## Stellaris<sup>®</sup> LM3S5951 RevB1 Errata

This document contains known errata at the time of publication for the Stellaris<sup>®</sup> LM3S5951 microcontroller. The table below summarizes the errata and lists the affected revisions. See the data sheet for more details.

Figure 1. Workaround Circuit to Ensure Initial Power Up

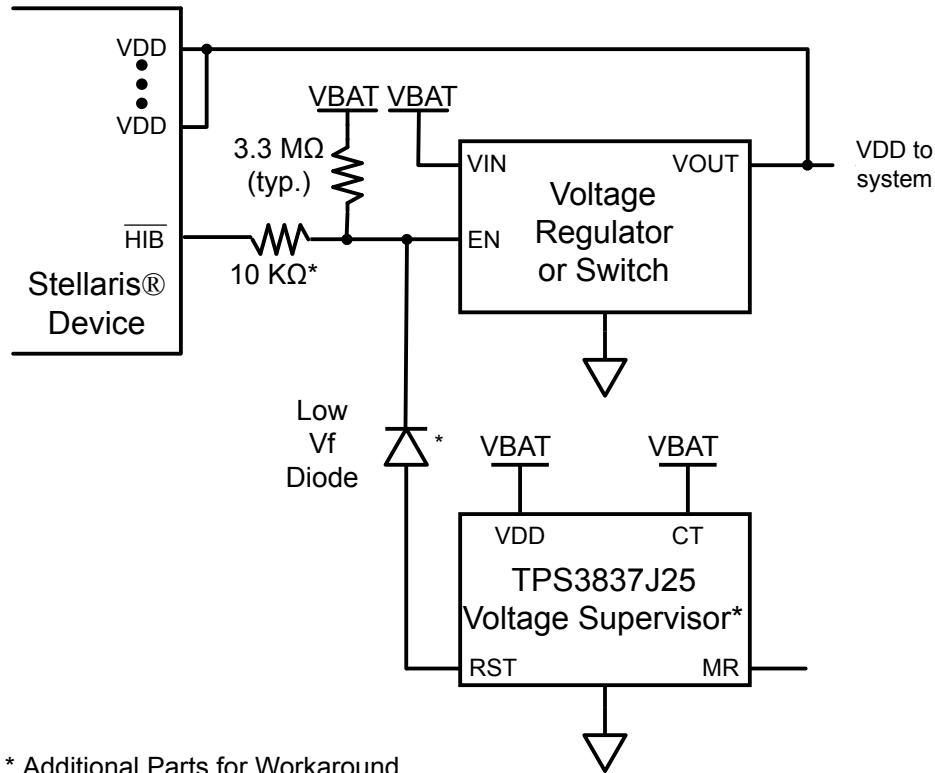
If  $V_{DD}$  is not powered when voltage is first applied to  $V_{BAT}$ , the state of the Hibernation module is indeterminate and the  $\overline{HIB}$  signal may be asserted. In this indeterminate state, a lock condition can occur in which the Hibernation module waits for a power-on-reset, but that reset cannot occur until the module deasserts  $\overline{HIB}$ . This issue is related to the errata "Hibernation module may have higher current draw than specified in data sheet under certain conditions" on page 5.

The workaround implementation depends on the system-level power supply configuration. For systems that use a battery as the primary power source, an external voltage supervisor (TPS383J25DBV or similar) circuit can be added to force the  $V_{DD}$  power supply to start when the battery voltage is first applied (see Figure 1). The voltage supervisor requires only 220 nA and generates a 200-ms positive pulse to turn on the  $V_{DD}$  regulator and activate the microcontroller's internal POR circuit.

**Figure 2. Configuration of External Regulator**

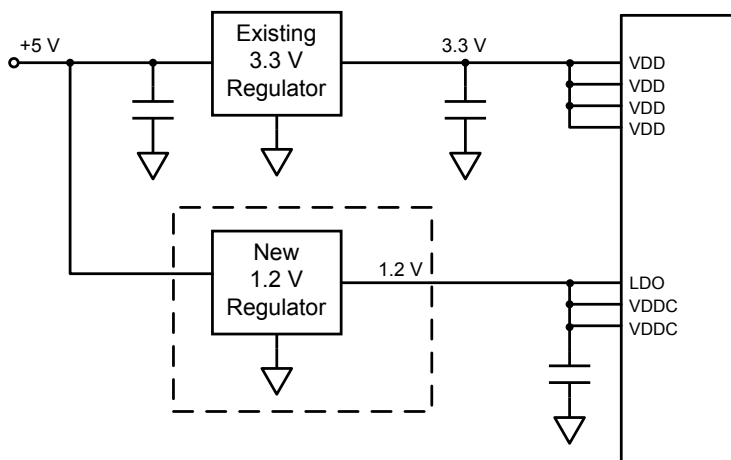
Incorrect power sequencing during power up can disrupt operation and potentially cause device failure.

$V_{DDC}$  must be applied approximately 50  $\mu$ s before  $V_{DD}$ . Normally  $V_{DDC}$  is controlled by the part's internal LDO voltage regulator. The workaround requires the addition of an external regulator (see Figure 2) to ensure that  $V_{DDC}$  sequencing requirements are met (see Figure 3). Recommended regulators include FAN1112SX (SOT223) and FAN2558S12X (SOT23-5).
